## DETAILED ACTION

Art Unit: 3611

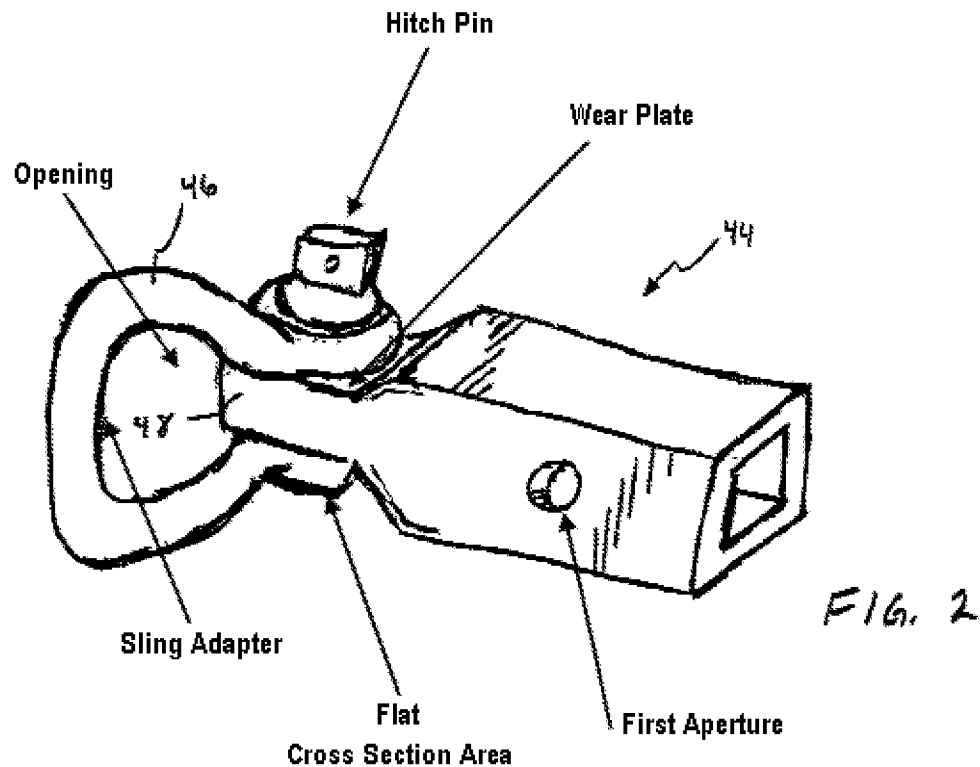
**Claims 1, 3-5, 15 and 17** are rejected under 35 U.S.C. 102(b) as being anticipated by Lloyd, U.S. Patent Application Publication No. 2002/0140206.

Lloyd discloses a hitch assembly [*adapter*] (44) [see included Fig. 2 below] for mounting into a hitch receiver (21) of a tow vehicle (Fig. 1) in order to tow a vehicle in need of towing, the hitch assembly (44) consisting essentially of: a coupling tongue [*elongate bar*] with a first end and a second end, the first end being received in the hitch receiver (21), the coupling tongue further comprising a first aperture sized to engage a coupling pin (31) (Fig. 1) at the first end, and a second aperture sized to engage a hitch pin at the second end; a U-shaped clevis [*D-ring*] (46) with a first clevis end and a second clevis end, that is substantially flat in cross section and consists of an aperture at the first clevis end and the second clevis end, the U-shaped clevis (46) being pivotally coupled to the second end of the coupling tongue with the hitch pin, and an opening formed by the coupling tongue and the U-shaped clevis (46), sized to receive a towing member [*i.e. ropes, chains and straps*] {Para [0030], Lines 3-5} that is also attached to the vehicle being towed; a wear plate [*mounting plate*] (48) located at both ends of the U-shaped clevis (46); and a sling adapter [*inner surface of U-shaped clevis (46) for contacting and bearing the load from the towing member*] being disposed in the U-shaped clevis (46) of the hitch assembly (44).
